Application for Variation of an Environmental Permit

C1. Name of the Current Environmental Permit Holder :
Highways Department
C2. Application No. of the Current Environmental Permit : EP-541/2017
C3. The Current Environmental Permit was Issued in : month / year

**CE72/2015 (HY) Flyover from Kwai Tsing Interchange Upramp to
Kwai Chung Road**

Environmental Review Report

Drawing no. FIGURE 2.1		Rev. -	
Drawn DH	Date 08/10/2020	Checked MW	Approved KL
Scale AS SHOWN		Status EER

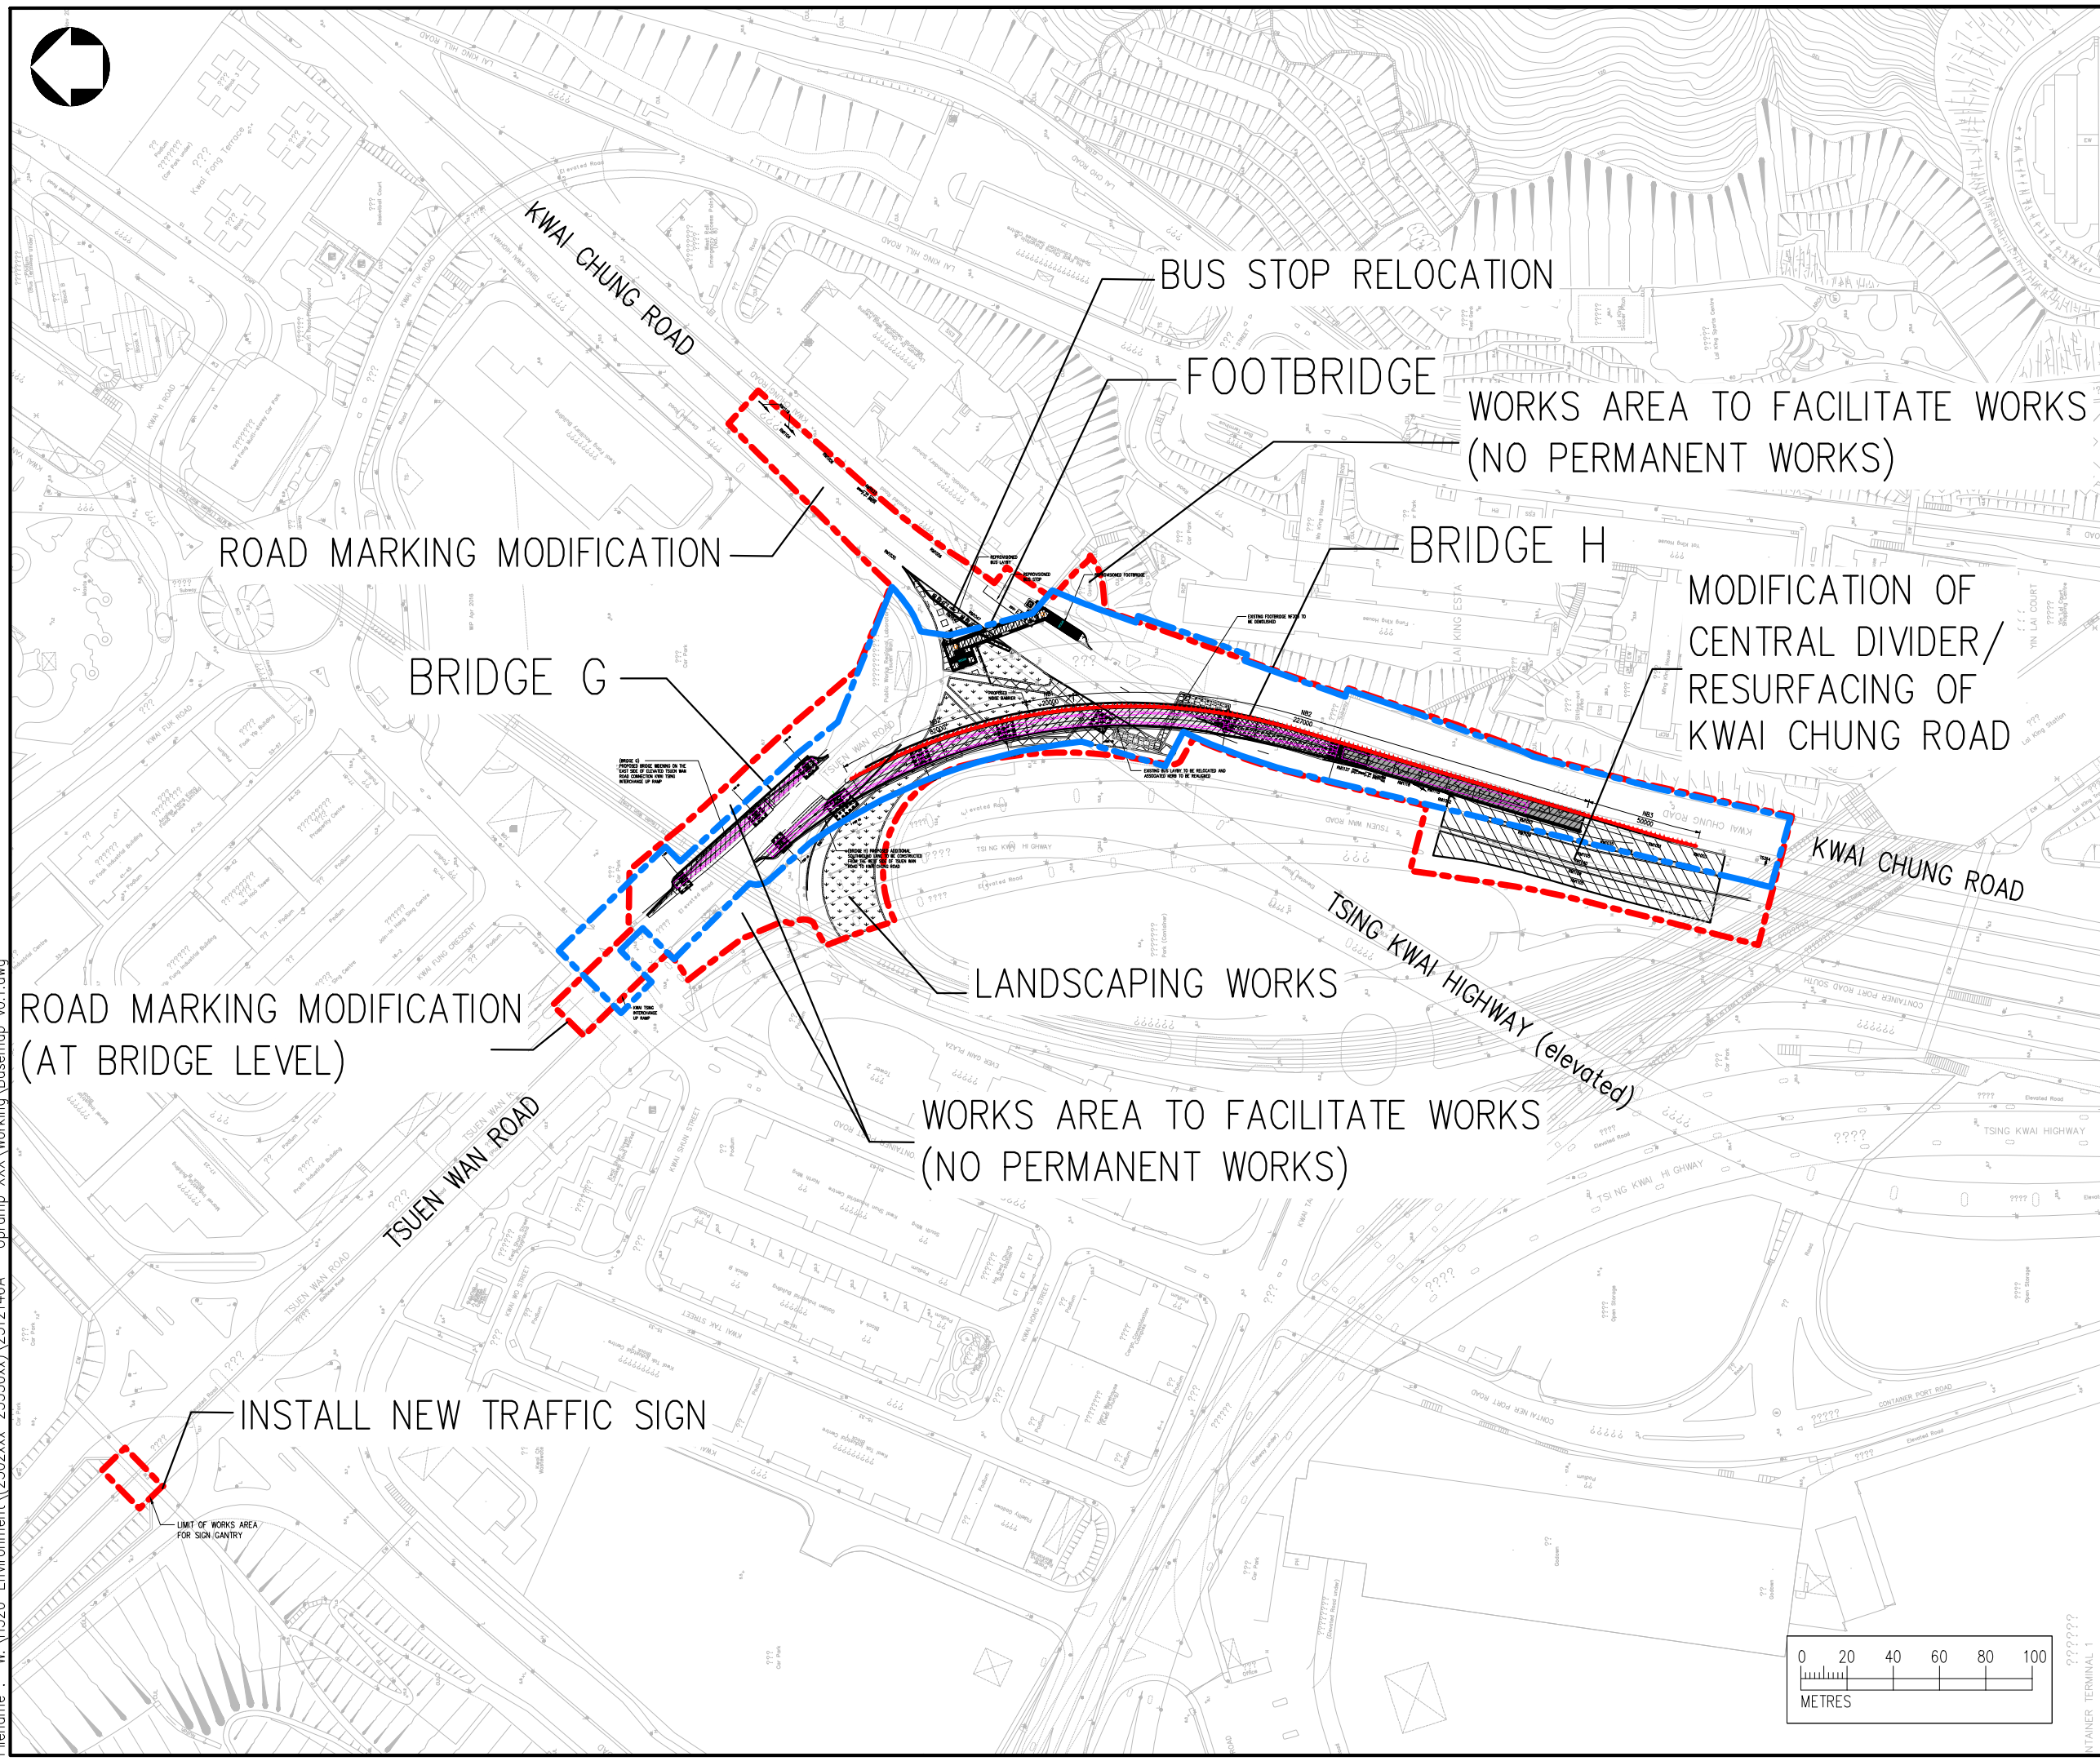
- 2.2.2 To cope with the proposed road widening and construction of additional southbound lane from the elevated Tsuen Wan Road (southbound fast lane) to the at-graded Kwai Chung Road, relocation of bus stop, the existing traffic lanes and road marking at different locations should be modified to maintain a smooth driving experience.

- 2.2.3 During the construction of the additional southbound lane, phased Temporary Traffic Management (TTM) arrangement is required, thus the existing planter between Container Port Road South should be removed during construction and will be reinstated in permanent operation and the landscaping area will be reinstated as well.

- 2.2.4 As there is modified road marking at the concerned area, a new directional sign is required at upstream (at footbridge NF286) for giving a clear notice to drivers in advance.

- 2.2.5 The above-mentioned works are shown in **Figure 2.1**. A figure showing the works areas as presented in the approved EIA Report is included in **Appendix 2.1**.

3.3.13 A new directional traffic sign will be erected at the existing footbridge at Tsuen Wan Road as shown in **Figure 2.1**. The works will be minor and limited.

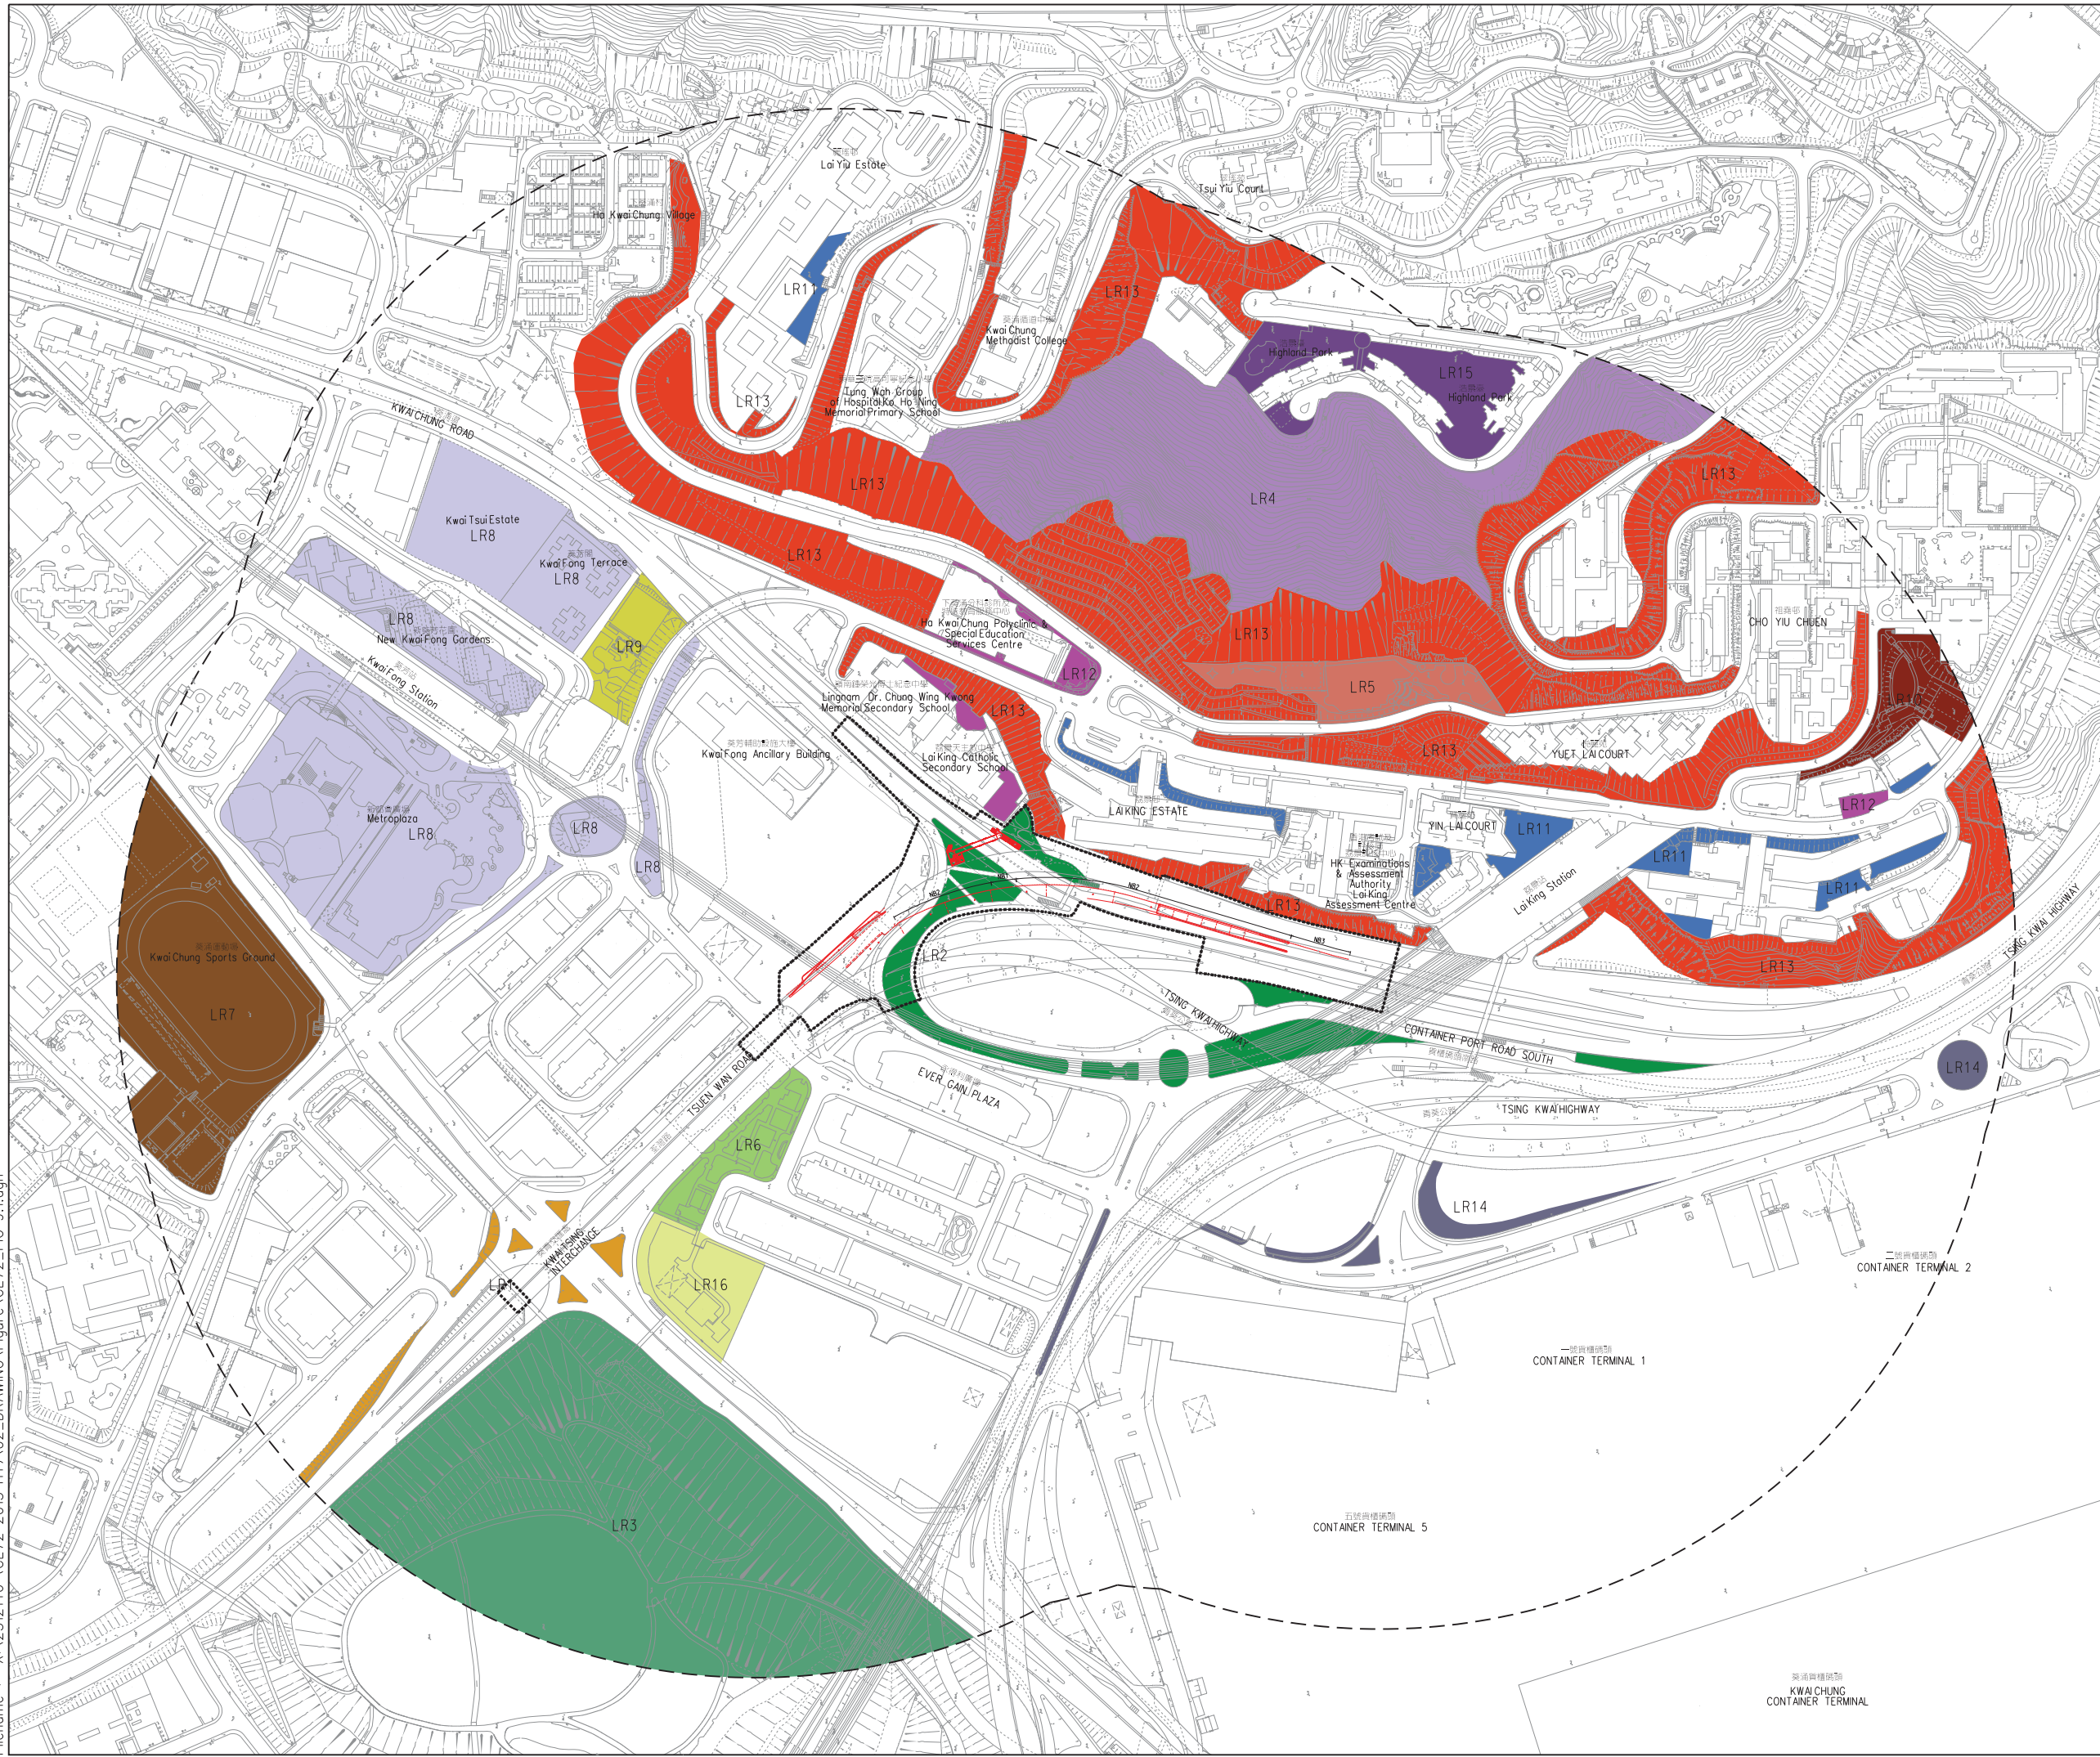
- 8.3.1 The extended areas have been overlaid to the Landscape Resources (LR) Plan and Landscape Character Area (LCA) Plan and shown in **Figure 8.1** and **Figure 8.2** and 1 LR and 3 LCAs will be affected. The recommended landscape and visual mitigation measures in the approved EIA Report is shown in **Appendix 8.2**. The location of these recommended mitigation measures will be adjusted to suit the proposed layout, but the recommended mitigation measures will remain the same as the approved EIA Report.
